SOAH DOCKET NO. 473-25-11558 PUC DOCKET NO. 57579

APPLICATION OF CENTERPOINT ENERGY HOUSTON ELECTRIC, LLC FOR APPROVAL OF ITS 2026-2028 TRANSMISSION AND DISTRIBUTION SYSTEM RESILIENCY PLAN **BEFORE THE STATE OFFICE**

CenterPoint Energy Houston Electric, LLC's Responses to Texas Industrial Energy Consu	mers
Third Set of RFIs	2-9
Certificate of Service.	10

See attachment "TIEC 3-04 Houston Wind Map.pdf" for an example of this map overlaid on the Houston Area.

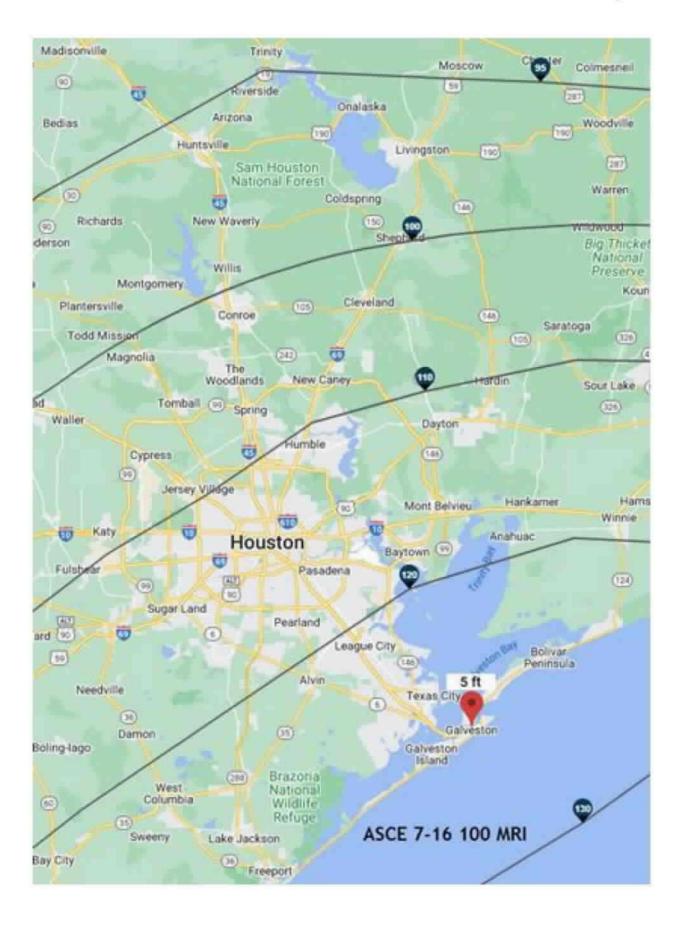
- a. Describe in detail the modeling that was done using PLS-CADD.
- b. Provide and explain the NESC wind speed criteria that was used.
- c. Provide a map identifying the wind speed criteria which CenterPoint applies to the various portions of its service area.

- b. Please see response to HCC RFP 4-26 (b).
- c. Please see NESC C2 2023 Figure 250-2(a) Grade B, 100-year Mean Recurrence Interval (MRI) 3 s gust wind speed map in mph (m/s) at 33 ft (10 m) aboveground (continued) (ASCE 7-16).
